#### IN THE DRAWINGS

Applicant has amended Figures 1 and 4 as indicated by the highlighting in pink highlighter on the enclosed drawing sheets.

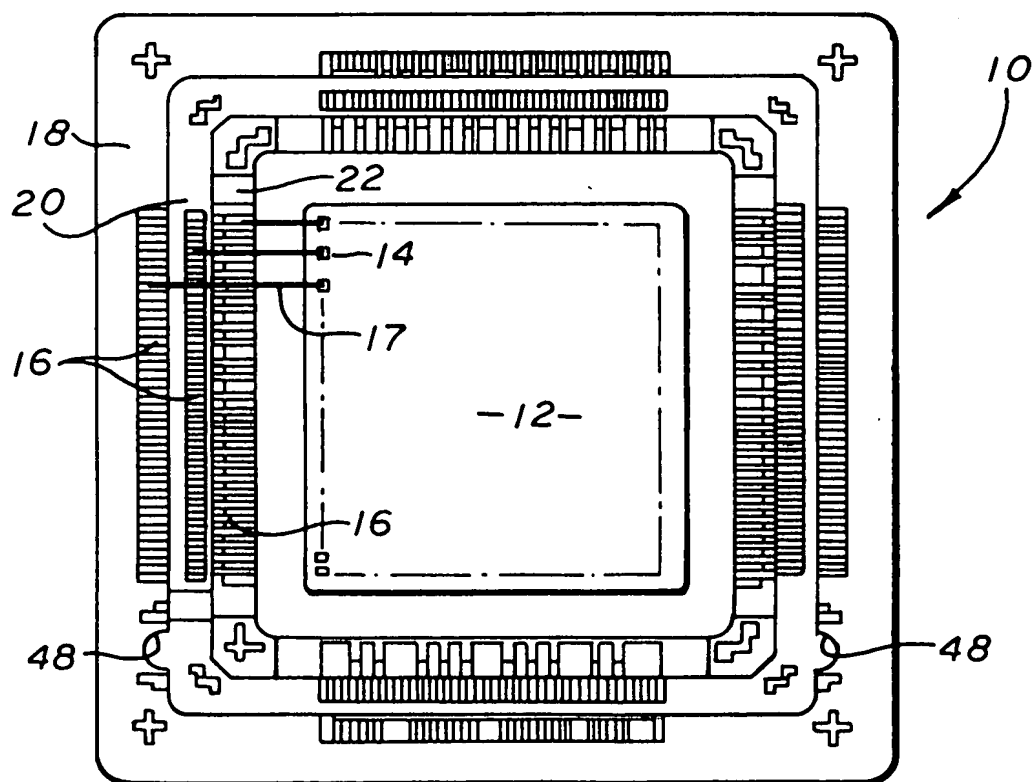
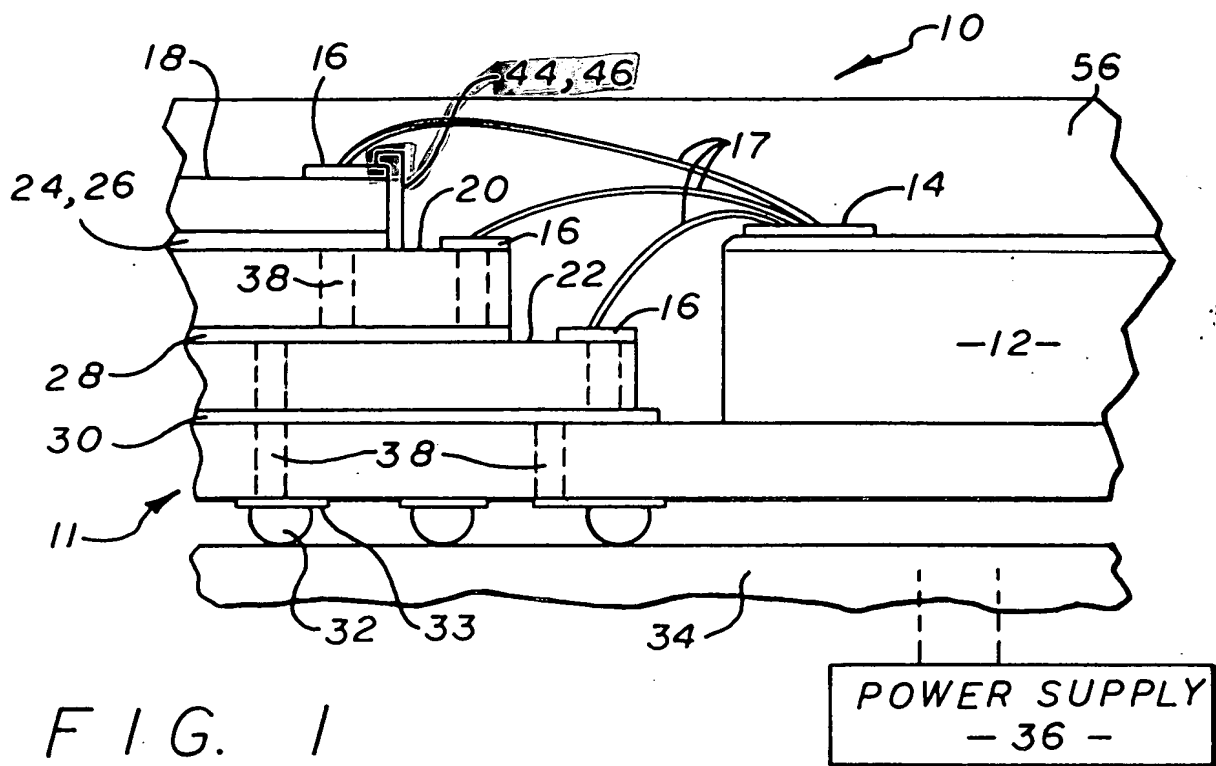
In Figure 1, the reference designators 44 and 46 ("44,46") are added to the conductive strip at the edge of the first bond shelf 18. Dashed lines between the pad 16 and busses 24,26 are deleted. The connection between the conductive strip 44,46 and the bond pad 16 is amended to be clearly shown in accordance with Figure 7.

FIG. 4

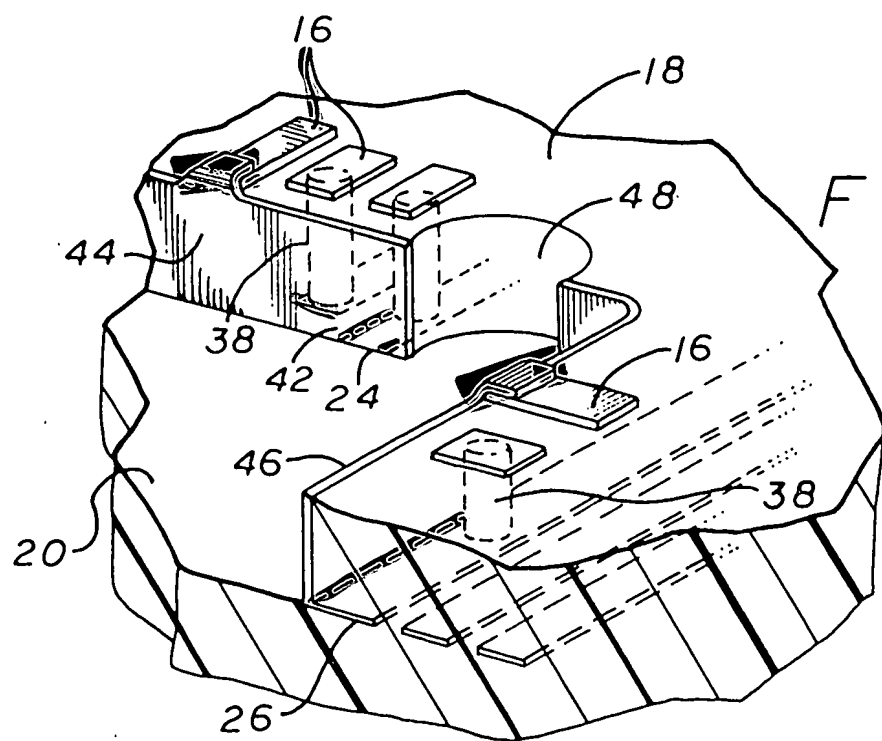
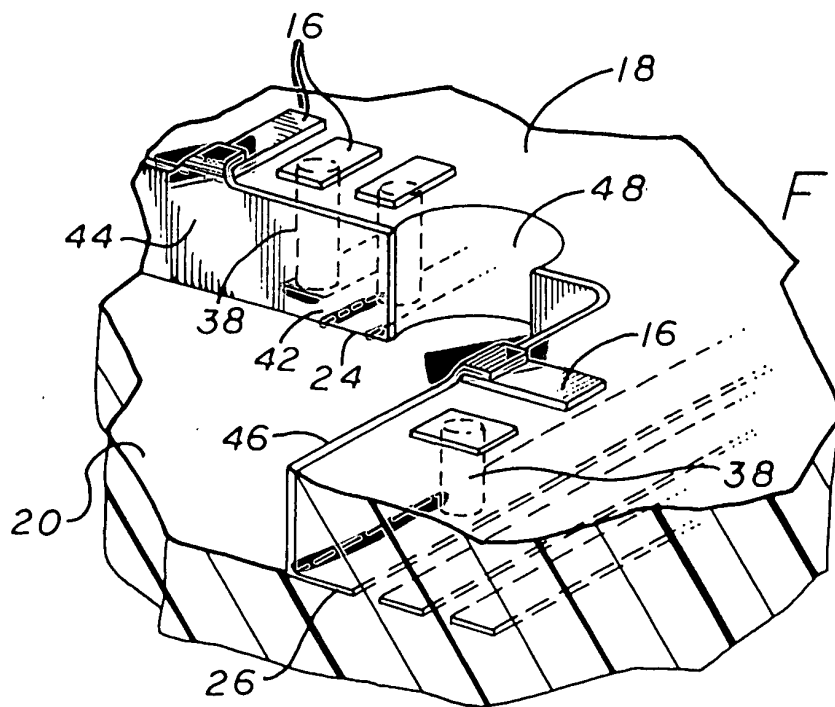
In Figure 4, the end of busses 42, 24, are amended to more clearly show how bus 24 connects to strip 44 in accordance with Figure 1. The width of bus 26 is amended to more clearly show how bus 26 connects to strip 46. The connection between the conductive strip 44,46 and the bond pad 16 is amended to be clearly shown in accordance with Figure 7.
